**MP 608 – Marshall, Michigan Incident
NTSB/PHMSA Information Request No. 129**

129 Reference: Email request (3 of 3, #3) by Matt Nicholson of November 9, 2010

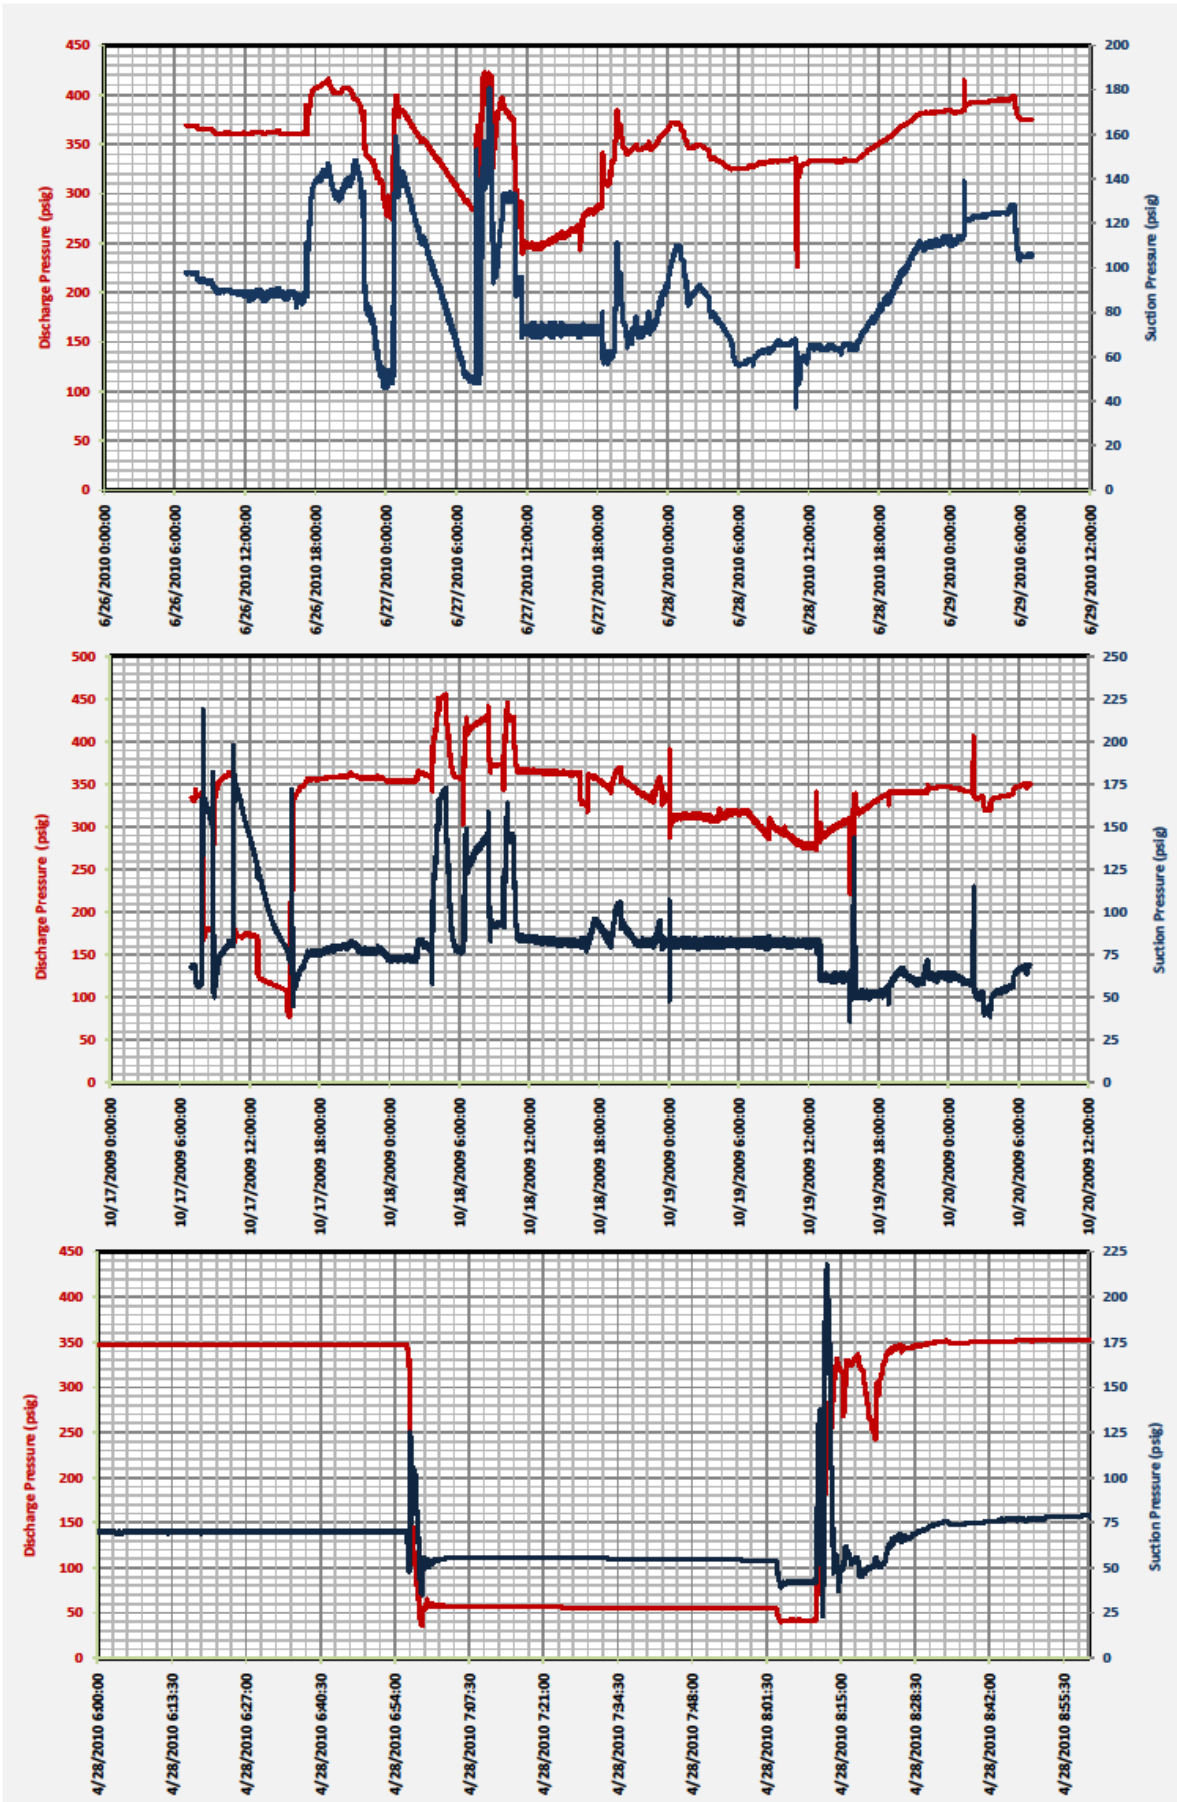
Request: Please clarify between which times the column separations are occurring in the trends provided under IR59. Are these upstream or downstream of Marshall? Which sections of 6b are these 3 column separations associated with (see attached plots)?
MARSHALL COL SEP HISTORY (sm).pdf

Marshall Elevation is 927.17ft, highest upstream elevation is at milepost 602.5, at 967.85ft. The highest downstream elevation before the check valve is at milepost 620.62, at 983.60ft. Using heavy crude (930kg/m³), a confirmed column separation would occur on a static line when Marshall suction pressure is less than 16.4psi, and when Marshall discharge pressure is less than 22.7psi.

1. 6MR 2009 Oct hist: no column separation occurred either upstream or downstream. Lowest suction pressure was 40psi; lowest discharge pressure was 77psi.
2. 6MR 2010 Apr hist: no column separation occurred either upstream or downstream. Lowest suction pressure was 26psi; lowest discharge pressure was 33psi.
3. 6MR 2010 Jun hist: no column separation occurred either upstream or downstream. Lowest suction pressure was 31psi; lowest discharge pressure was 226psi.

The sections in the attached plots refer to suction and discharge pressure at MR Station
